City of Aurora
Building Codes Division
15151 E Alameda Pkwy
Aurora, CO 80012
(303) 739-7420

August 27, 2009

Plan Review Clarification
Reference Number (RSN): 481073
Project: Job Address: 1501 S Potomac St – 4th Floor Renovation

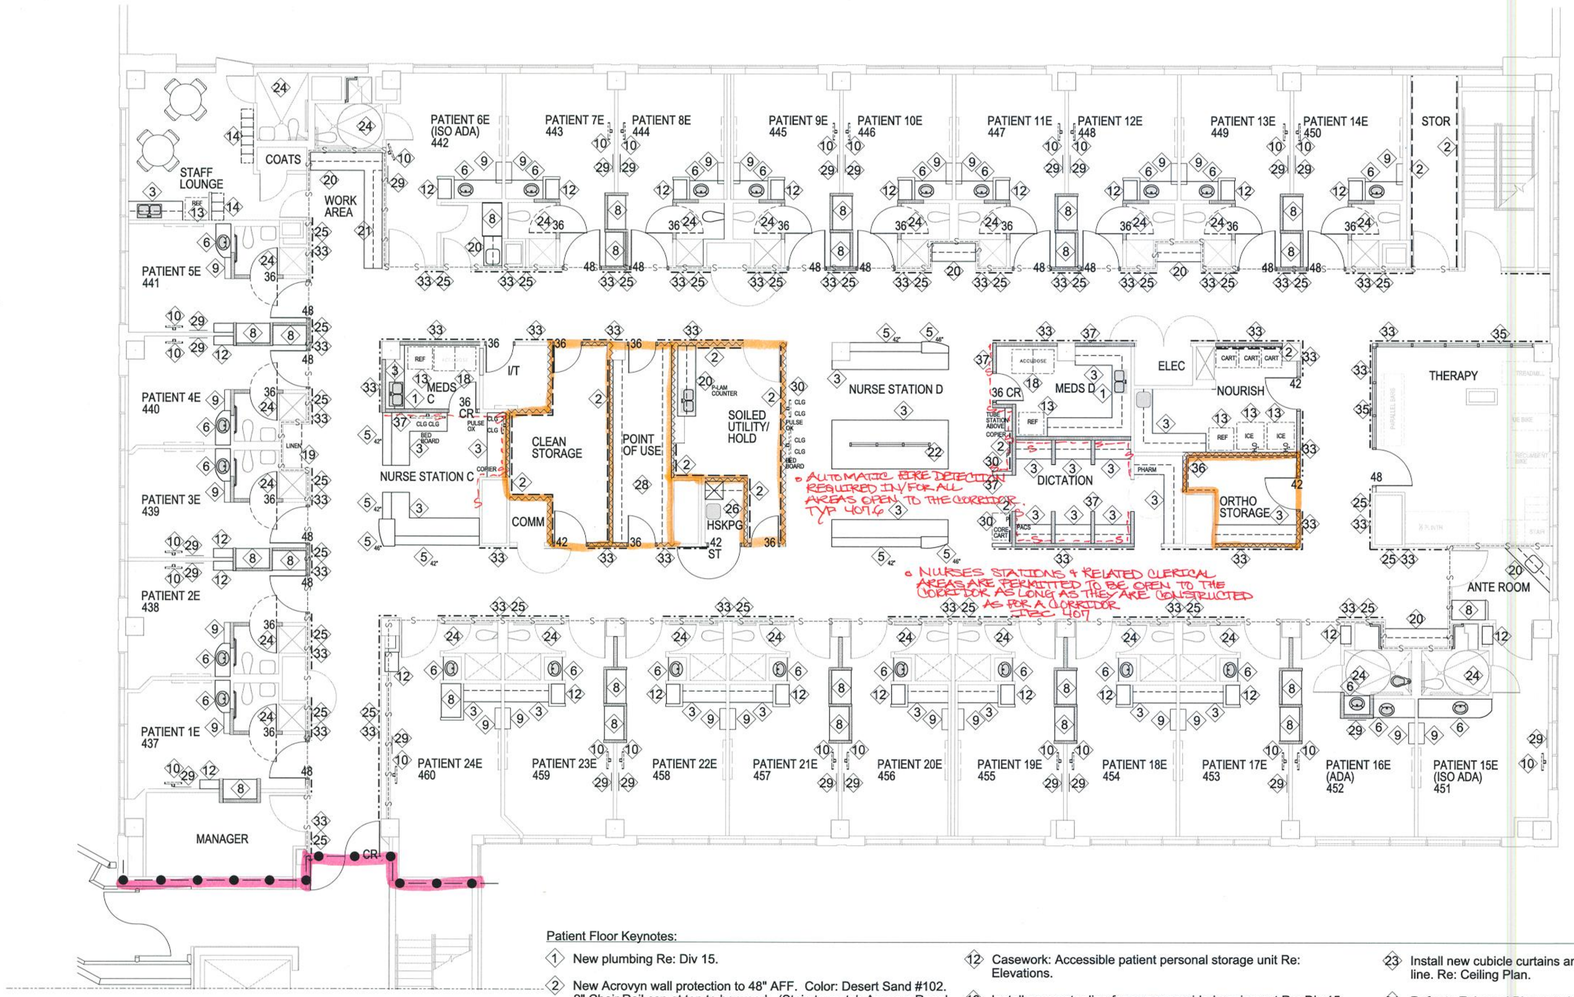
Please see the attached plan which shows the Med Prep Rooms off each Nurse Station with a one hour rated wall around it. The intention of your redlines was to separate the rooms not open to the corridor from the corridor, and consider the Nurse Station as part of the corridor, per IBC 2006 section 407.2.2. The Dictation and Pharmacy workstations on the East Wing are considered doctor work areas, and therefore I have shown a one-hour wall added behind the spaces, rather than around them as you had indicated on our permit set. This wall is shown in red for clarification purposes.

These are workstations open to the corridor without a door, so it would be impossible to create a one hour wall or smoke partition around them. I believe the change to the location of the one hour wall shown on the attached meets the intention of your redline.

sheet title
FOUR EAST FLOOR PLAN

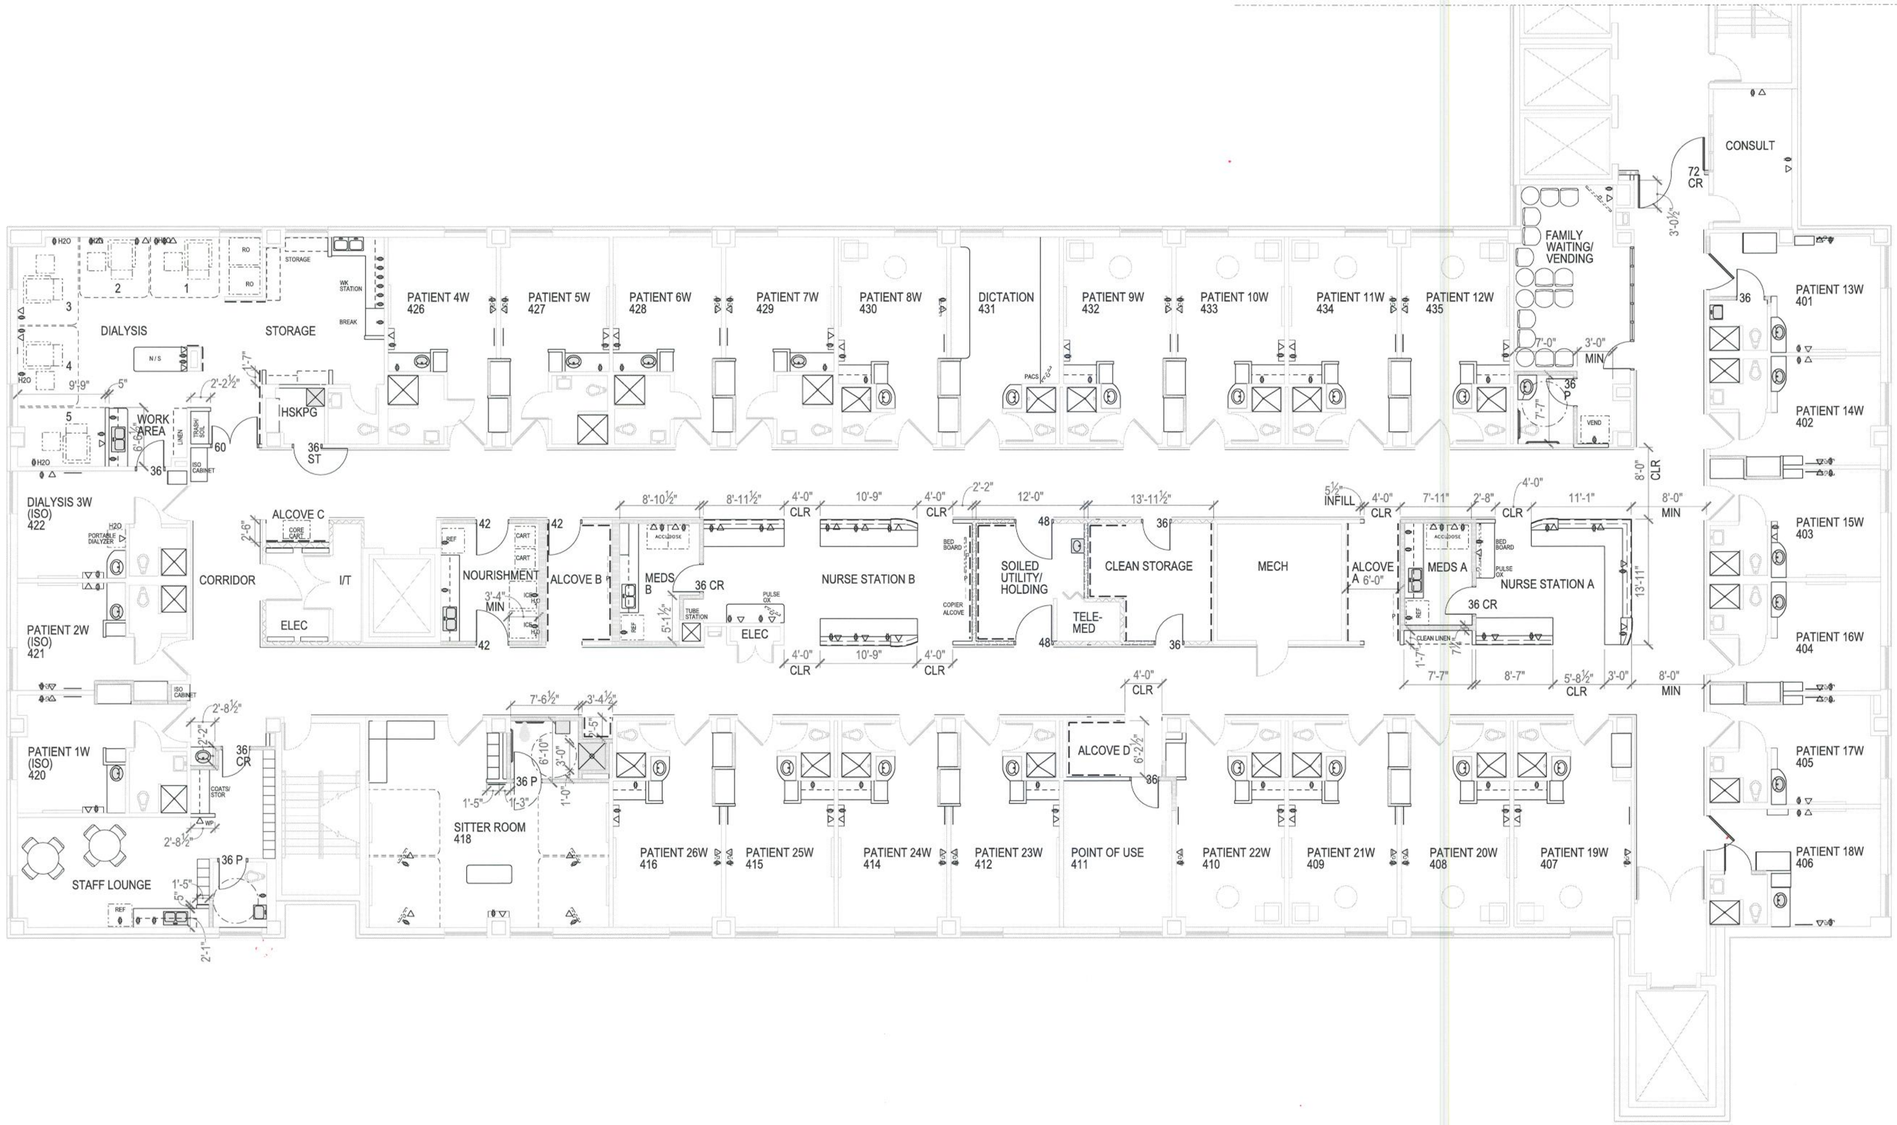
PLAN REVIEW 3 — NOTE: All rooms shown with a 1 hour partition (new or existing) shall have a door/frame assembly with a 45 minutes label, smoke seals, and closer.

40. Upgrade wall to 1 hour construction.
41. Existing smoke doors to remain.

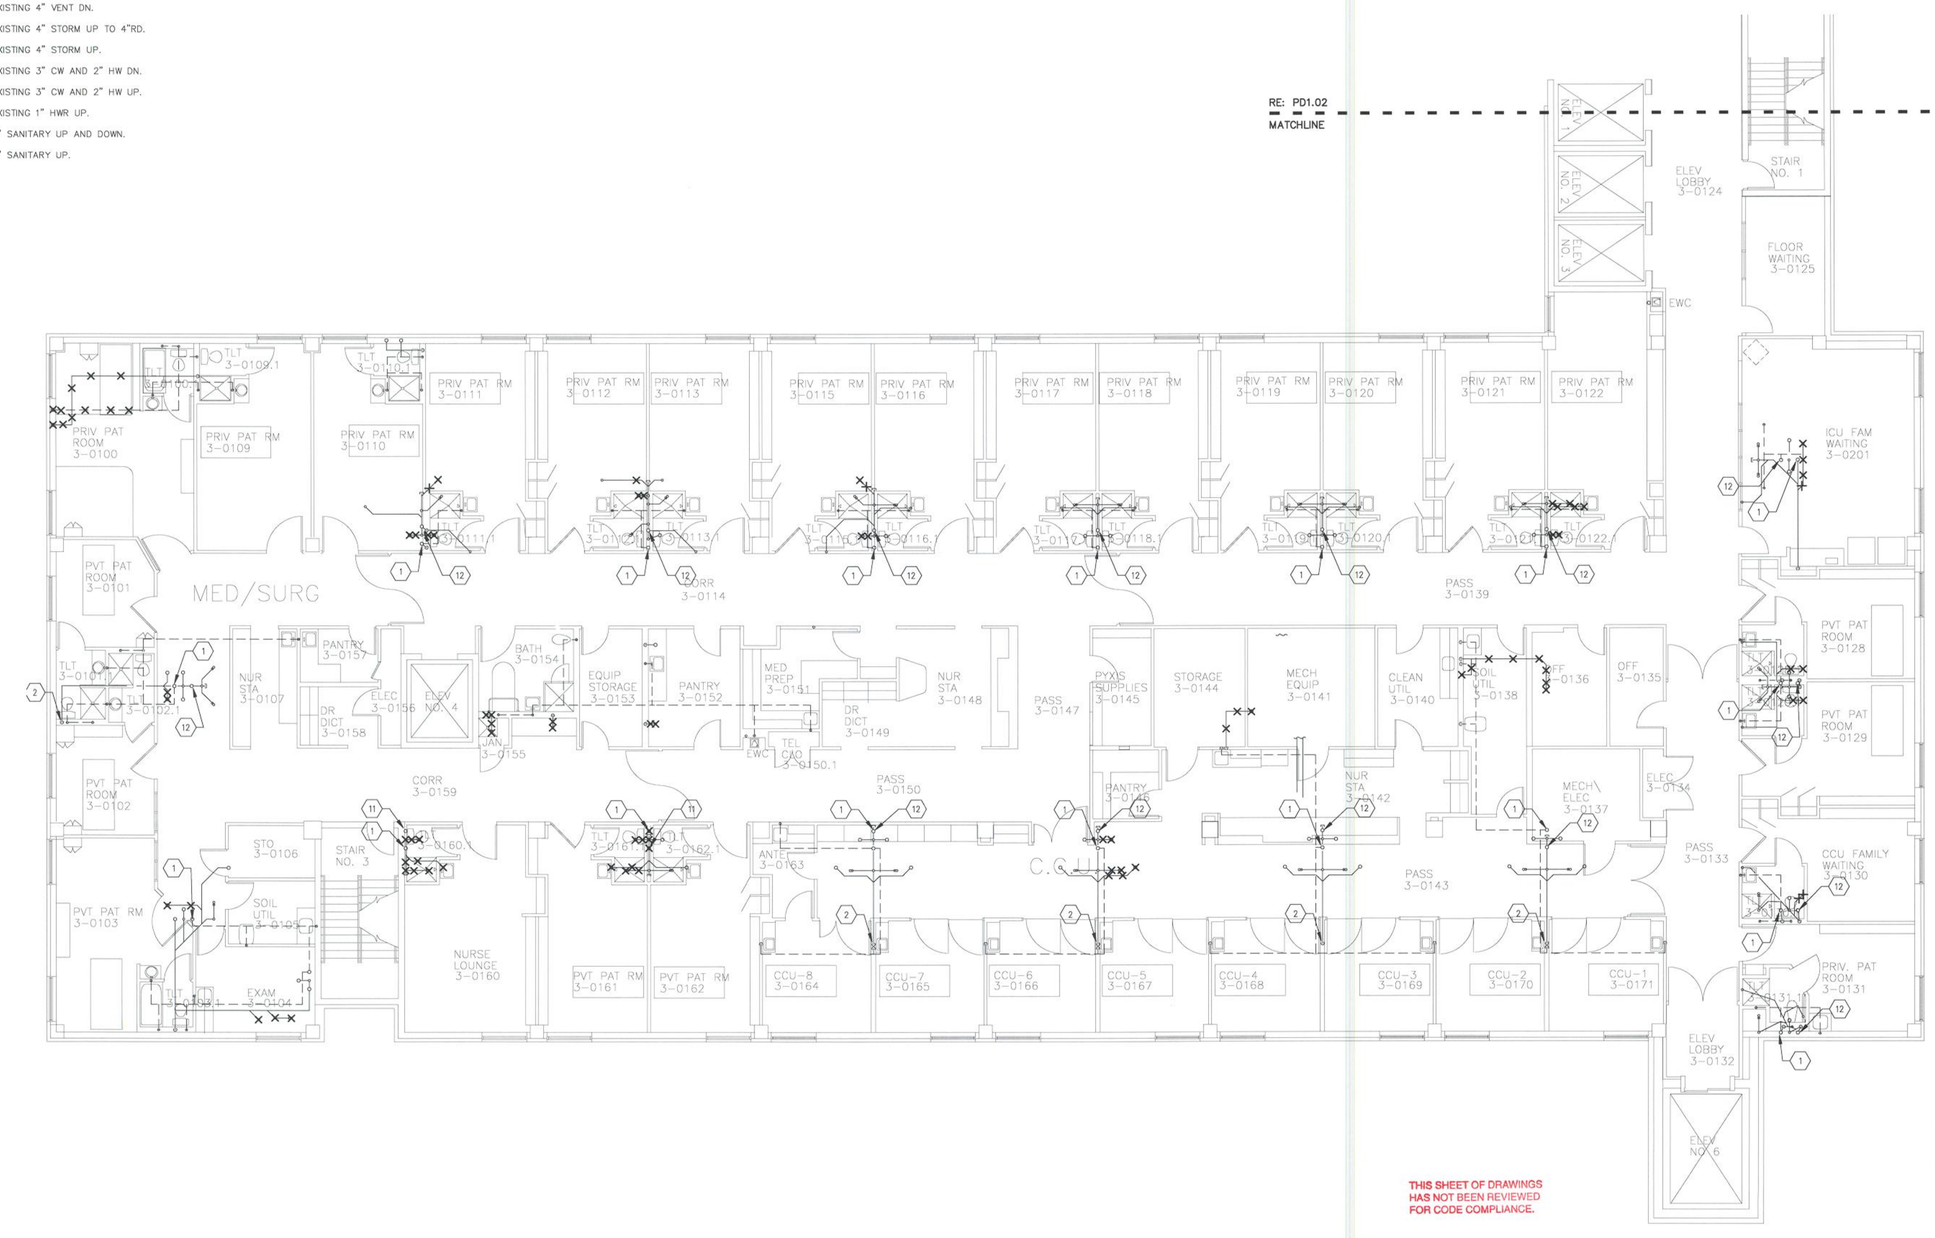
Provide self closing or metering type of faucets in restrooms per 2006 COA 22-323(b) PUBLIC
